**Total Maximum Daily Load  
To Address Biological Impairment in**

**Rugg Brook (VT05-07)**

**Franklin County, Vermont**

**October 2008**

**Figure 5.** High flow portion of the flow duration curves for Rugg Brook and attainment stream.

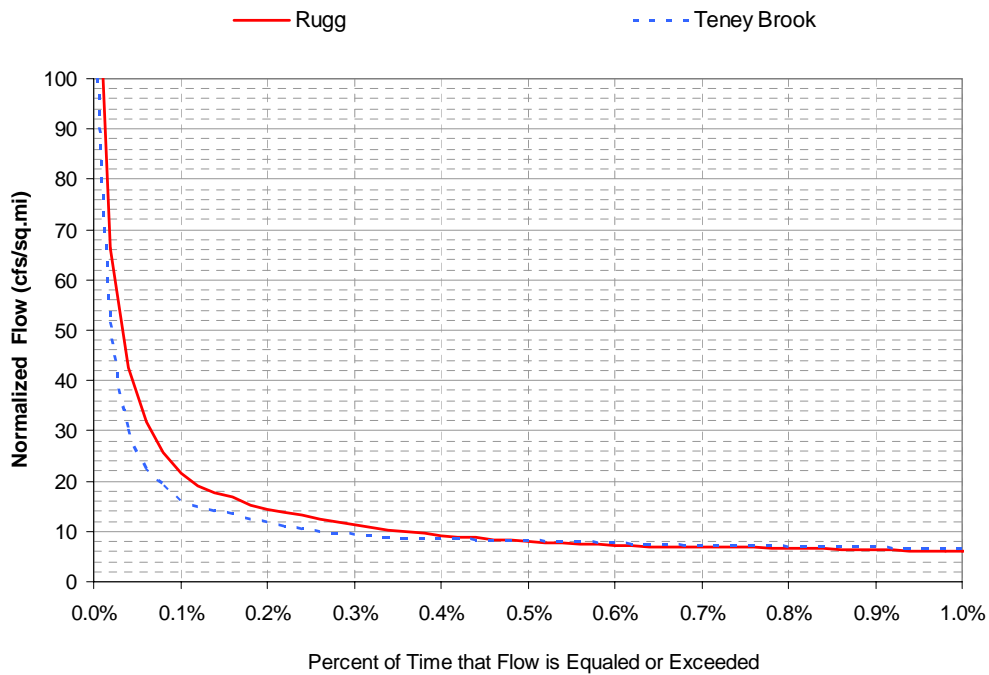
4. Page 14. The coincident of the graphs in Figure 5 does not seem to support a significant expenditure of resources to reduce stormwater related flows in Moon Brook. [Rutland]

Response: As noted in the TMDL, the high flow reduction target from current modeled conditions is 12%. Across the spectrum of the stormwater impaired streams for which TMDLs have been developed, this percent flow reduction is relatively modest. However, at this time watershed-specific implementation planning and cost estimates have not been developed to estimate the resources required to achieve this target.
